Giant Mine Environmental Assessment

IR Response

INFORMATION REQUEST RESPONSE

EA No: 0809-001

Figure 1: Simplified Model Sensitivity Analysis for Thermosyphon Performance at Chamber 12

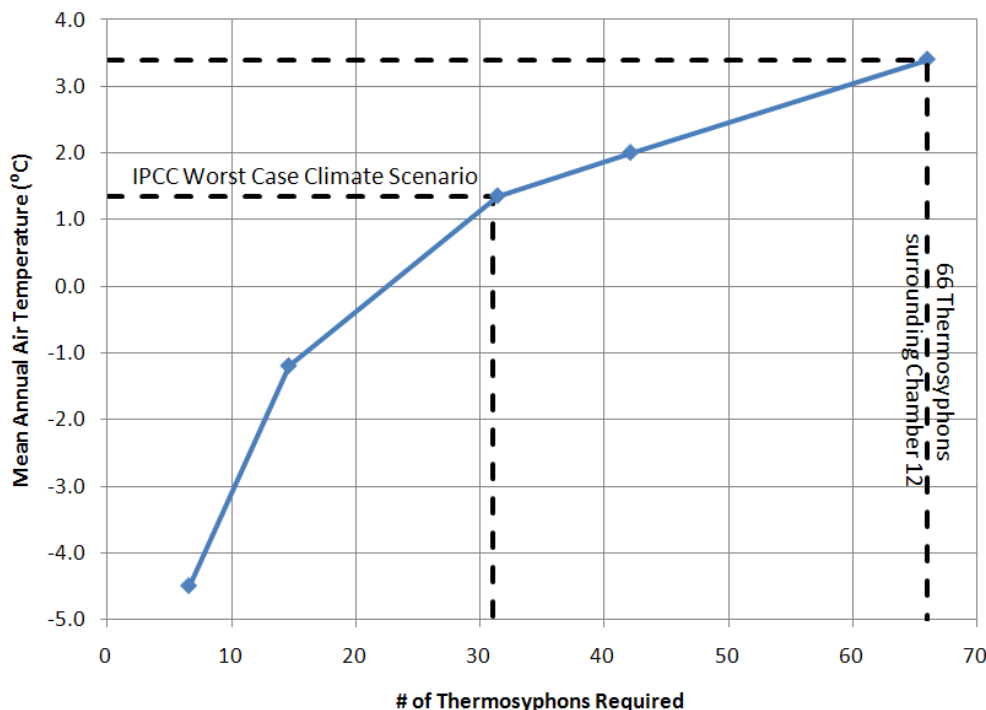
1. Please provide results of sensitivity analysis, that, independent on any assumed climate change scenario,
 - a. show the minimum air freezing index / average seasonal air temperatures required for the frozen block to remain frozen using the passive cooling method;
 - b. provide information on the energy consumption required as a function of various air temperatures for an active / hybrid system; and
 - c. provide estimates of thaw times as a function of various air temperatures, assuming that active, hybrid or passive systems fail.
2. Please present a series of graphs showing these trends.
3. Please provide electricity demands and related costs if active or hybrid freezing is required over the long term.

Section 6.2.8.2 of the Developer's Assessment Report (DAR) presents a simplified model for Chamber 12 that evaluates the theoretical number of thermosyphons required to maintain stability for various climate change scenarios. Chamber 12 was used in the calculations as previous model simulations have shown it to be the most sensitive to thawing due to its location in a prominent bedrock outcrop. The resulting number of thermosyphons ranged from 13 to 52 for the IPCC worst case global warming scenario. As the current plan includes 66 thermosyphons around the chamber, the simplified model concluded that there is adequate cooling capacity to keep Chamber 12 frozen. Further details of the model calculations are presented in Section 6.2.8.2.

The simplified model presented in the DAR assumed each thermosyphon had a radiator size of 19.5 m^2 . The thermosyphons currently used in the FOS have 39 m^2 sized radiators. The figure below shows the results of the same calculations, using the revised thermosyphon radiator size and a wider range of climate change scenarios. The scenarios have mean annual air temperatures ranging from the current $-4.5 \text{ }^{\circ}\text{C}$ to $+3.4 \text{ }^{\circ}\text{C}$.

Calculations using a mean annual air temperature of $3.4 \text{ }^{\circ}\text{C}$ resulted in 66 thermosyphons being required, matching the layout shown in the DAR. The DAR describes the simplifying assumptions used in the analysis. The limitations means the model should not be relied upon for design, but does show the robustness of the current concept.

Figure 1 Unfrozen volumetric water content curves on arsenic trioxide samples for different degrees of saturation¹.

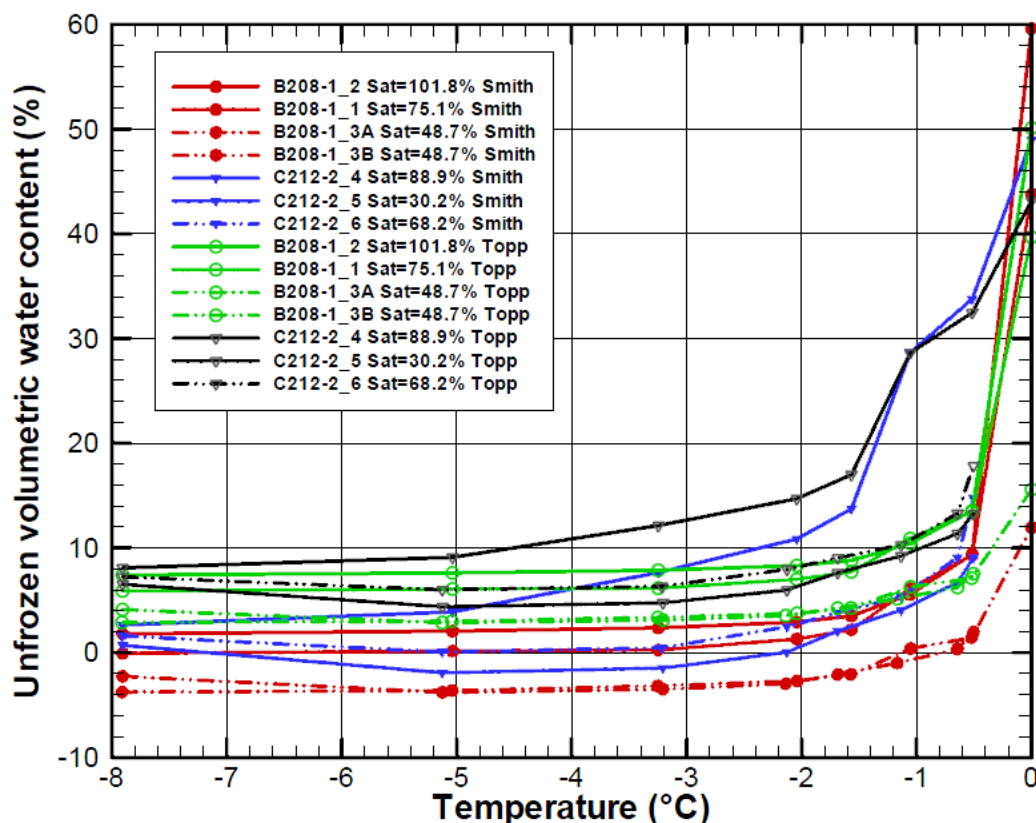
1. Please clarify
 - a) the potential of change in freezing point depression as a function of freezing rate;
 - b) the factor of safety associated with the -5°C criterion and point of completely frozen conditions (no unfrozen water present);
 - c) the change in hydraulic permeability as a function of negative temperature and degree of saturation;
 - d) the assessment of the potential seepage through the frozen block assuming best estimates for the frozen hydraulic permeability; and
 - e) the use of the term “thaw” within the DAR and a clear definition, which preferentially is defined on an acceptable hydraulic permeability, hence unfrozen water content

Figure 1 of the 'Physical properties of overburden, bedrock and arsenic dust' memo, below, shows the unfrozen volumetric water content curves on arsenic trioxide samples for different degrees of saturation. Between temperatures of -5°C and -8°C (temperatures at which tests were completed), there was very little change in the unfrozen water content. The -5°C criterion was chosen as there is very little additional benefit gained by cooling the arsenic dust below this temperature. It should be noted the unfrozen water content (ranging from 0 to 9% in the tests) will largely be bound by ice and immobile, in addition to being encapsulated by the frozen bedrock shell.

The term thaw is used in the DAR to refer to the transition between frozen and unfrozen conditions. For the arsenic trioxide, as shown in the figure presented above, this transition largely occurs between -0.7 °C and 0 °C. For the bedrock material, no unfrozen water content testing was completed. In the thermal modeling simulations described in the Conceptual Engineering for Ground Freezing report, phase change was assumed to occur between temperature of -0.5 °C and -0.1 °C.
